SERVICE BULLETIN

SB_SPXP_010
Revision 00

SB_SPXP_010 Engine Cooling Baffle

Installation of an engine cooling baffle.

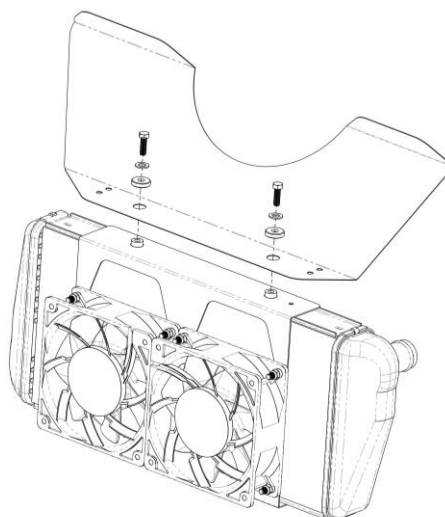
- Remove engine cowlings.
- Remove the upper bolts, washers and bushings that fix the aluminum support of the engine cooling fans (see picture below).

The aluminum support do not need to be removed.

- c) Install the baffle and fix it using the bolts, washers and bushings.
- d) Check the electrical wiring of the cooling fans is not running across the sharp edges of the baffle. Isolate the wiring from the baffle by installing the grommet in the sharp edge.

- e) Check the gap between the fiber baffles of the lower cowling and aluminum baffle. If necessary, adjust the fiber baffle by sanding.
- f) Reinstall the engine cowlings and check the baffle for position and gap with the upper engine cowling.
- g) Make the following logbook entry:
